Appln. No. : John P. Biel, Jr. et al
Amdt. Dated : November 16, 2004
Reply to Office action of : October 5, 2004
Page 15

REMARKS/ARGUMENTS:

Amendments to the Drawings:

FIG. 8

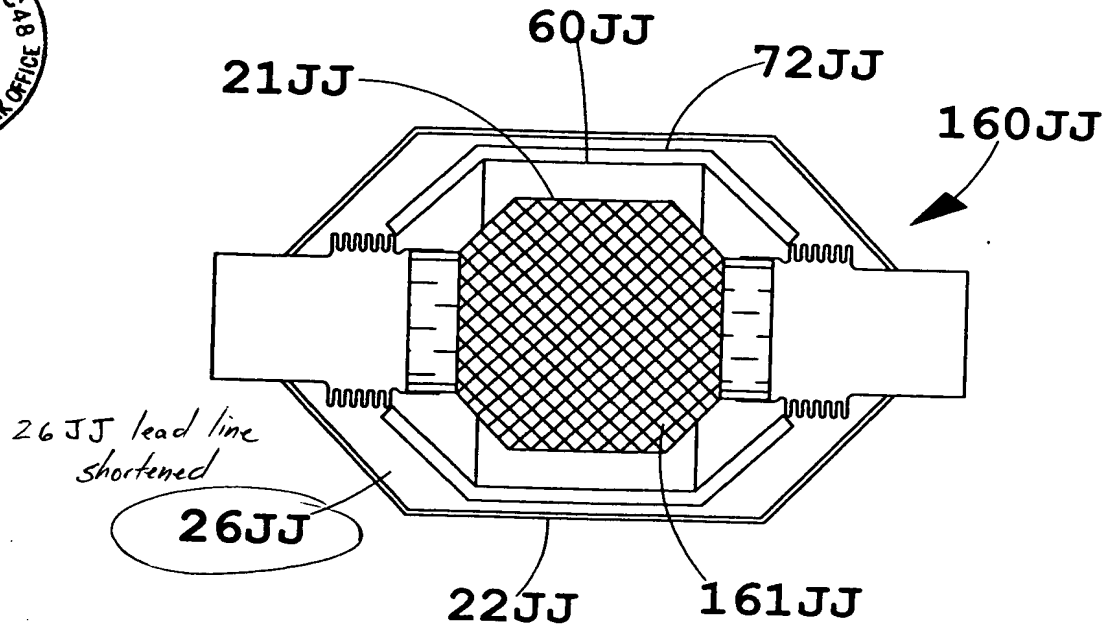
The attached sheets of drawings includes changes to Figs. 1, 2, 3 and 8. These sheets replace the original sheets for Figs. 1, 2, 3 and 8. In Fig. 1 and 2, previously omitted elements 49" and 90A have been added. In Fig. 3, elements 21B and 22B have been corrected to point to the inner housing and outer housing, respectively and Fig. 8 has been amended to show that the lead line for element 26JJ points to the vacuum cavity.

FIG. 1

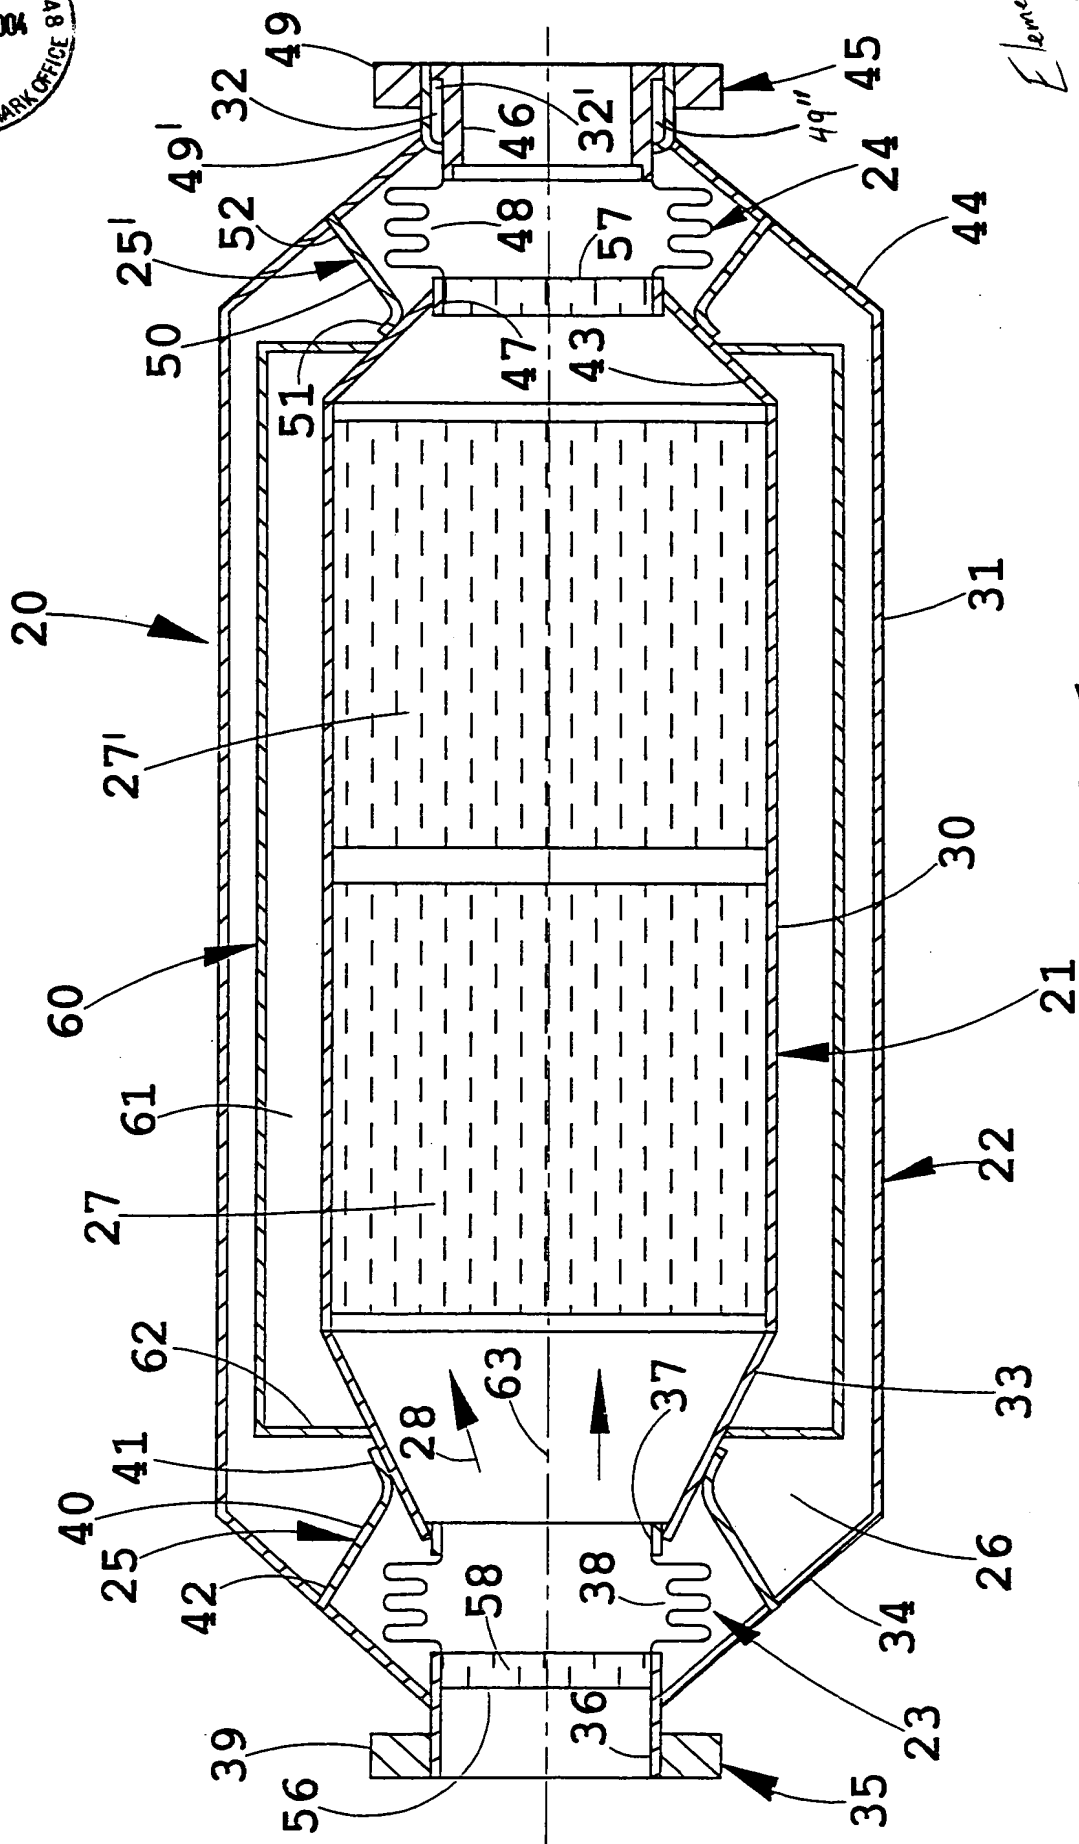
A request to amend Figs. 1, 2, 3 and 8 is submitted herewith. Examiner states that "the drawings are objected to as failing to comply with 37 CFR 1.84(p)(5) because they include the following reference characters not mentioned in the description: 49" (page 6, line 6); 90A (page 10 line 27)." In Fig. 1, the reference character 49", which points to an "annular space," has been added to conform with the requirements set forth in 37 CFR 1.84. Furthermore, in Fig. 2, the reference character 90A has been added to point to the "electrical circuit" and a lead line has been added pointing 99A to the "sensor" to which it pertains. Reference characters 21B and 22B in Fig. 3 have been changed to point to the inner housing and outer housing, respectively. Furthermore, in Fig. 8, the lead line for reference character 26JJ has been shortened to point to the "vacuum cavity." No change was made with respect to the reference character 91II, as this reference character is present in Figs. 6 and 7 and is defined in the specification at page 14, line 16.

Element 49" added
